Teven Quarry Air Quality Management Plan

Holcim Australia
May 2022

Attachment A
Teven Quarry
Air Quality Management Plan Review – Oct 2020

Attachment A
Teven Quarry (SSD-6422) – Post Approval
Air Quality Management Plan Review – July 2021

Figure 1

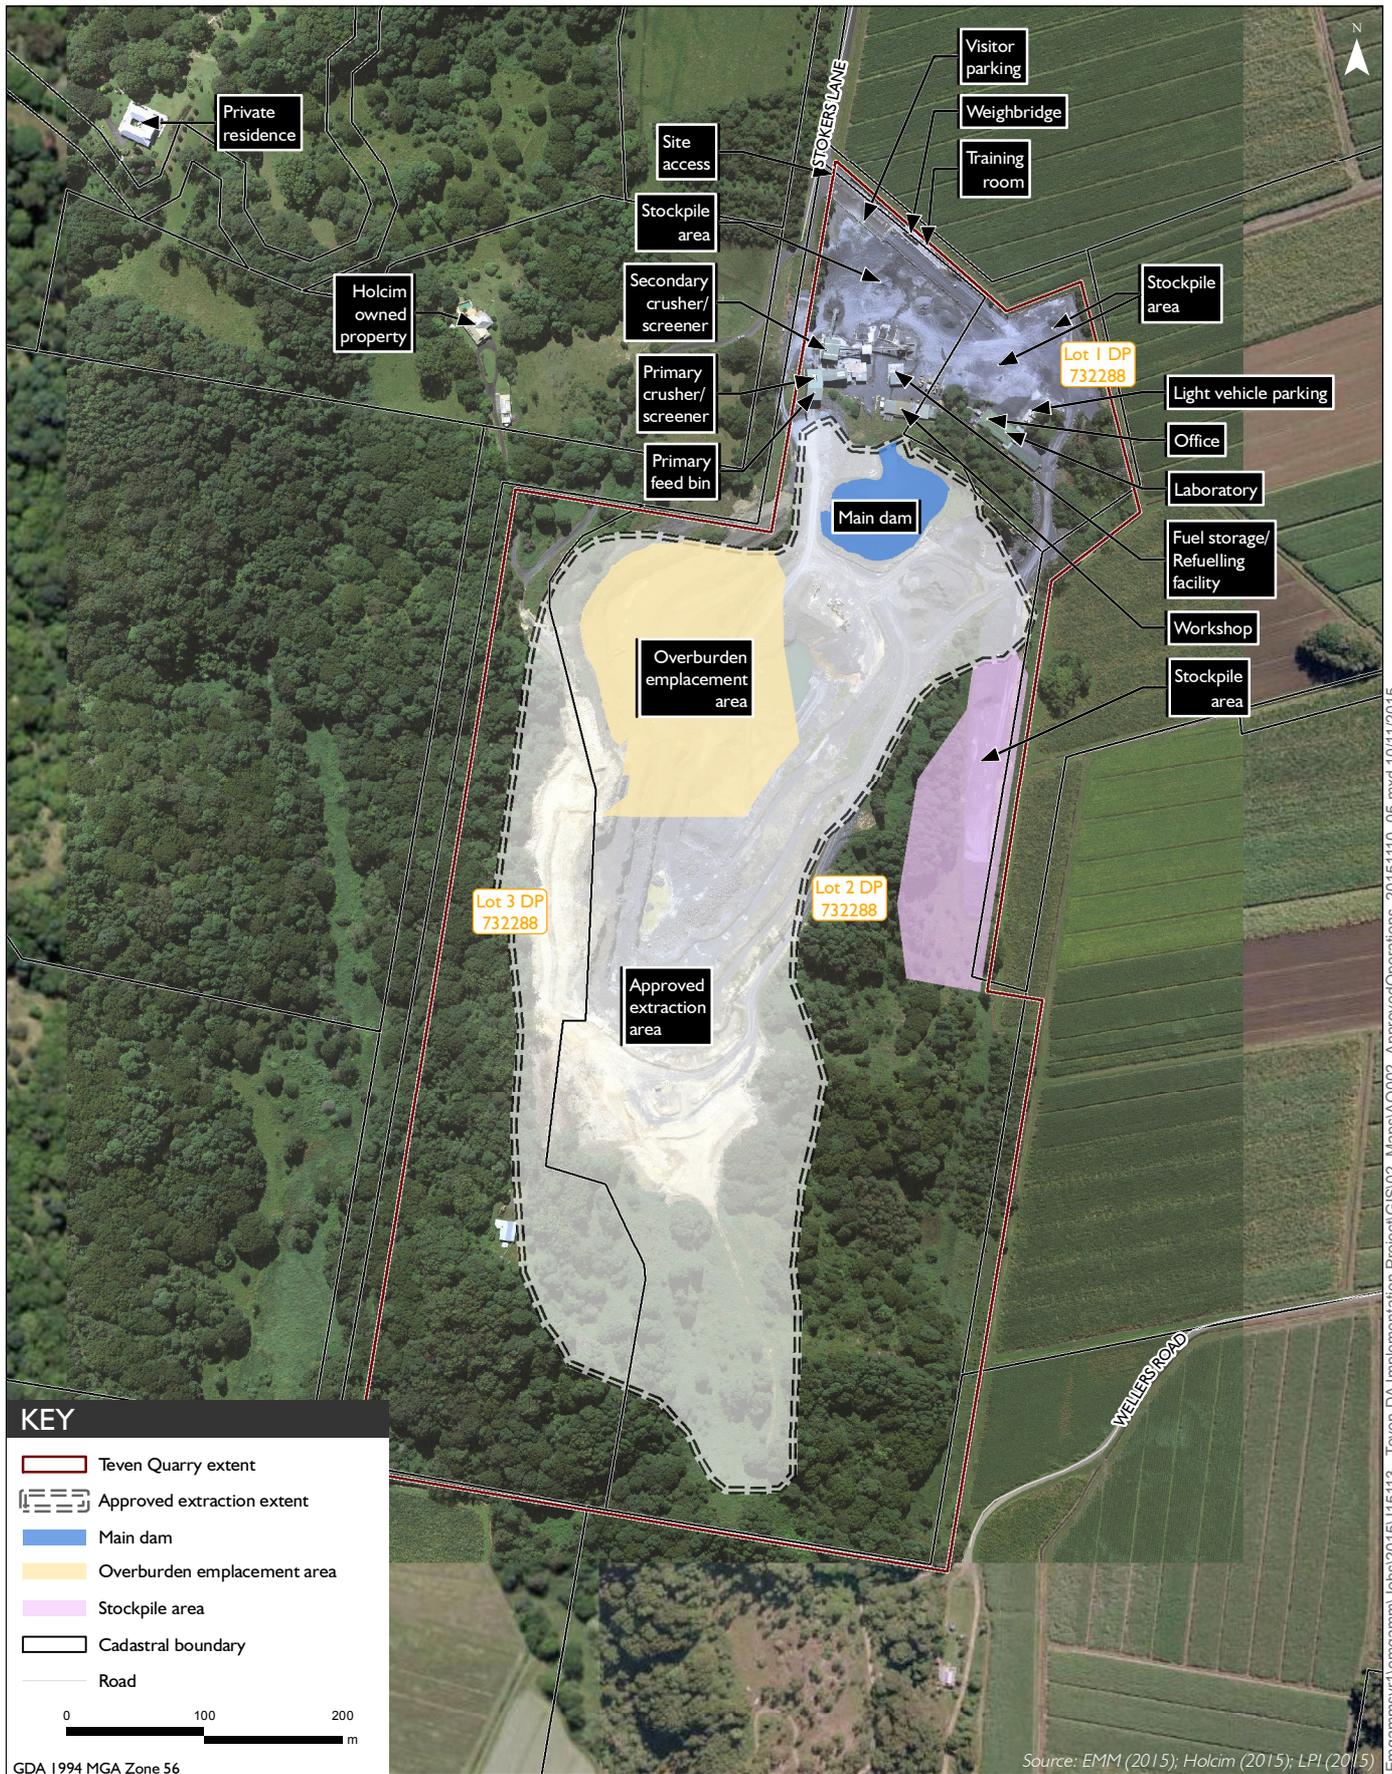
Other Comments				
<p>Figure 1 should include the current Pacific Highway route.</p> <p>S.2.2 How does Teven Quarry engage with surrounding landowners in respect of AQ?</p> <p>T.7 What is the basis for calculating TSP from PM10? What ratio is used?</p> <p>T.2 Schedule 3 Condition 11 & 12 particular matter should be <i>particulate</i> matter.</p> <p>T.2 Schedule 3 Condition 14b should have three-dot points instead of two.</p> <p>T.3 Statement of Commitments: The word <i>relevant</i> is missing from the last dot-point and the table finishes with where?</p> <p>T.6: All AQ & GHGE control measures are delegated to the Quarry Manager; however, the 2019 Independent Environmental Audit did not check how the manager fulfils their responsibilities.</p> <p>S.9.2 Dot-point 1: word missing after <i>high</i>. What is INX?</p> <p>S.9.2 Dot-point 3: DPIE does not support this approach as being capable of determining compliance with AQ criteria.</p> <p>S.9.2 Dot-point 4: Corrective Actions need to refer to S.10 T.8. S.10 needs to identify T.8 TARP as the quarry's Contingency Plan.</p> <p>S.12 T.9 PM1 Should the Low-Volume Air Sampler be a High-Volume Air Sampler?</p> <p>S.13 T.10 Why is the Support Services Supervisor included in T.8 TARP, not included in T.10?</p>				<ul style="list-style-type: none"> Figure 1 has not been changed rather the wording describing Figure 1 indicates it was drafted for the EIS. Teven engage with surrounding landowners through the site's community webpage as described in Section 6.3.2 of the
